**5.1 NO. 5 (LOT: 516; PLAN: 2177) BERRYMAN STREET, MOUNT HAWTHORN - CHANGE OF USE FROM SINGLE HOUSE TO SINGLE HOUSE AND RESTAURANT/CAFE****Ward:** North

**RECOMMENDATION:**

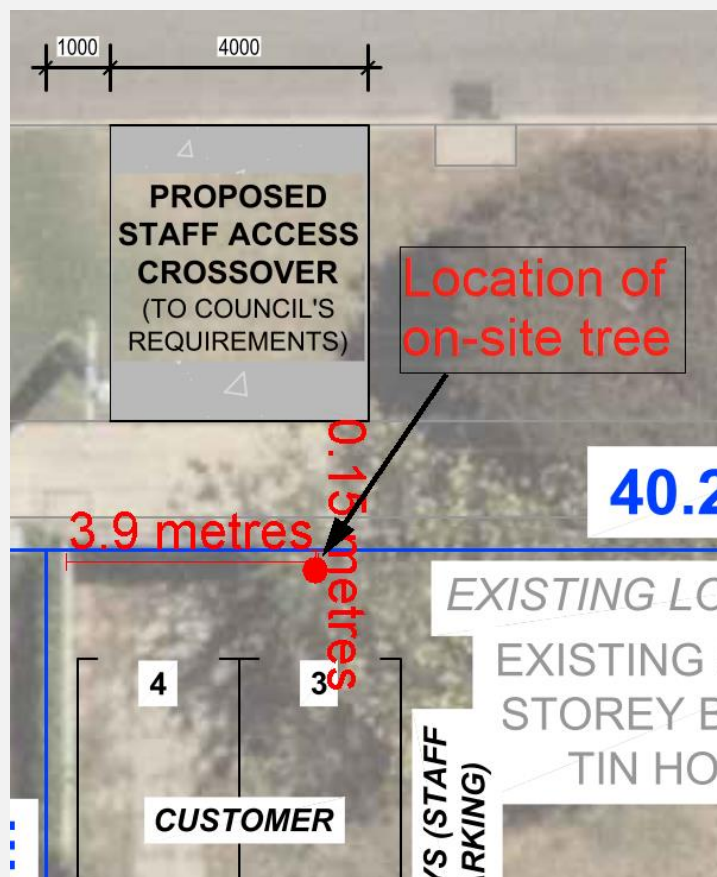
Following the Council Briefing session, it came to Administration’s attention that an existing on-site tree would need to be removed to accommodate the proposed Restaurant/Café parking arrangements.

The previous assessment undertaken by Administration, as presented within the Council Briefing report, was based on an understanding that the location of the tree was to the east of the car parking bays. This meant the tree could be retained as it would not conflict with the proposed driveway or any of the car bays.

Following on-site measurements, it has been confirmed that existing on-site tree is setback 3.9 metres from the western lot boundary and 0.15m from the street boundary, as shown in the below image. This means the tree would conflict with the proposed driveway to Car bay 3.

1. Removal of the on-site tree to accommodate Car Bay 1 and 3; or
2. Retention of the existing tree which means Car Bays 1 and 3 could not be provided. This option would result in a new departure regarding a shortfall of two customer parking bays on-site.

In considering the above two options, Administration would not be supportive of the removal of the on-site tree. This is because the proposal would not meet the objectives of the Built Form Policy where the retention of healthy and mature trees should be prioritised. The tree is a mature and healthy specimen with ongoing viability.

Following an assessment against the objectives of the Non-Residential Parking Policy, Administration are supportive of a shortfall of two (2) on-site parking bays. This is because there is sufficient on-street parking available within the immediate context, that would not detrimentally impact the surrounding area.

Option 2 is the preferred way forward as the tree would be retained and relevant parking objectives are achieved. To resolve this issue and proceed with Option 2, the officer report has been updated to reflect the required changes.
